STAFF COMMENTS FOR PLANNING COMMISSION

SITE PLAN: **SP-05-0004**

TITLE: **CROWN FARM POINTE**

REQUEST: **DISCUSSION of
Building Elevations**

4

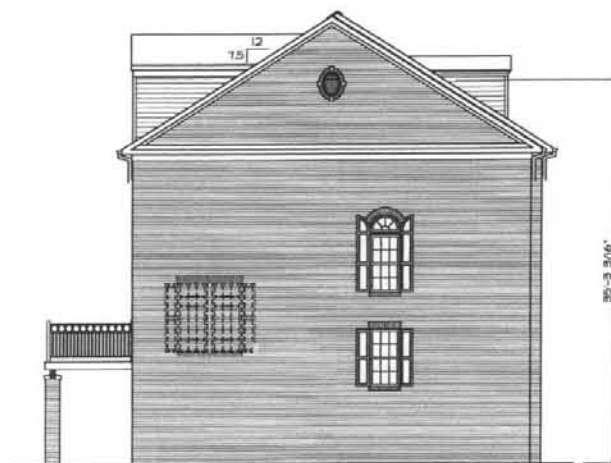
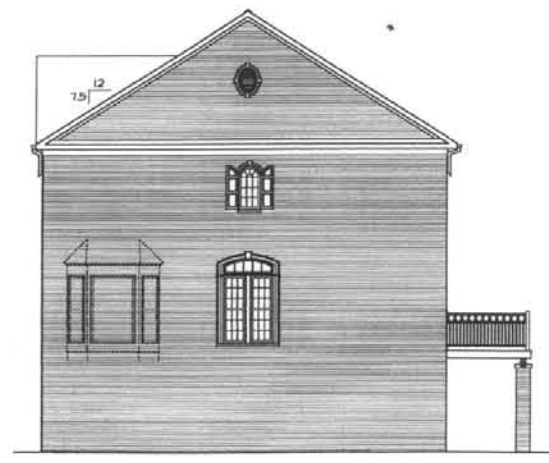
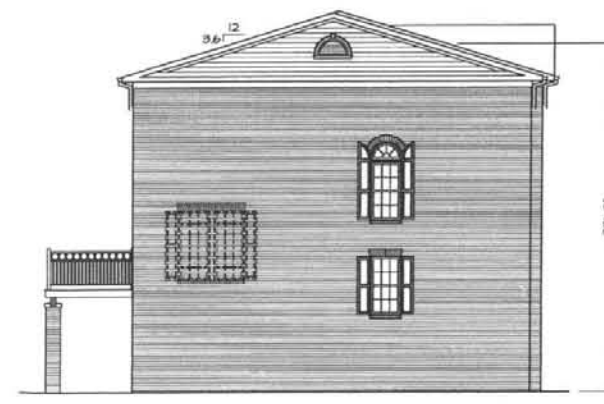
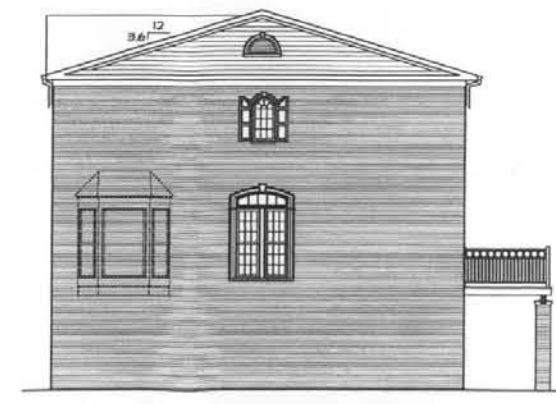
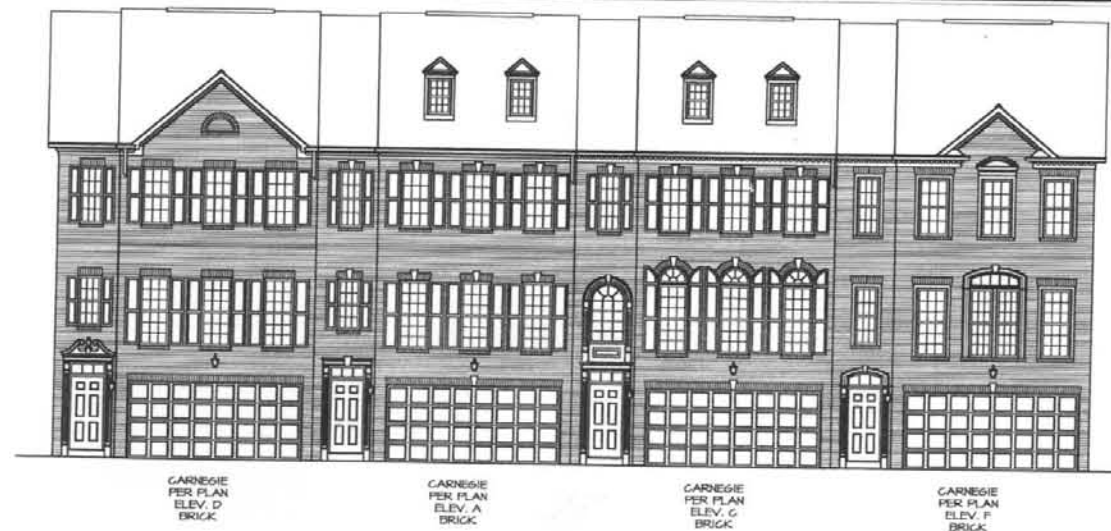
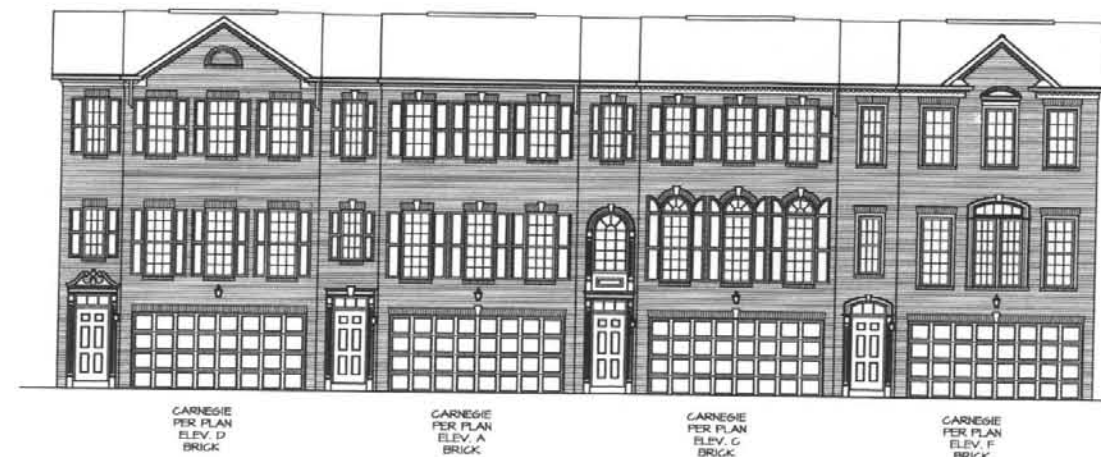
Since that meeting, the Applicant has submitted a signature set of engineered elevations. During the review of these "to-scale" plans, staff determined that these structures were not in compliance with the height restrictions in the RPT zone. Section 24-46 establishes that building heights in the RPT zone may not exceed thirty-five (35) feet. The measurement of building height is defined in Section 24-1, attached for your review.

Staff believes that the revisions proposed by the Applicant, to comply with the RPT zone, would be a significant change to the intent of the Commission's approval. Typically, staff would propose that the Applicant submit an Amendment to Final Plan application. Staff, however, believes that these proposed changes warrant a discussion with the Planning Commission to explore all possible options available, before proceeding with an AFP.

3 PROPOSED 4 UNIT BUILDING W/ 3.5/12 ROOF PITCH
A-1 SCALE: 1/8" = 1'-0" FRONT ELEVATION "A"

NOTE - DORMERS NOT AVAILABLE W/ 3.5/12 ROOF PITCH

4 PROPOSED 4 UNIT BUILDING W/ 3.5/12 ROOF PITCH
A-1 SCALE: 1/8" = 1'-0" FRONT ELEVATION "B"

NOTE - DORMERS NOT AVAILABLE W/ 3.5/12 ROOF PITCH
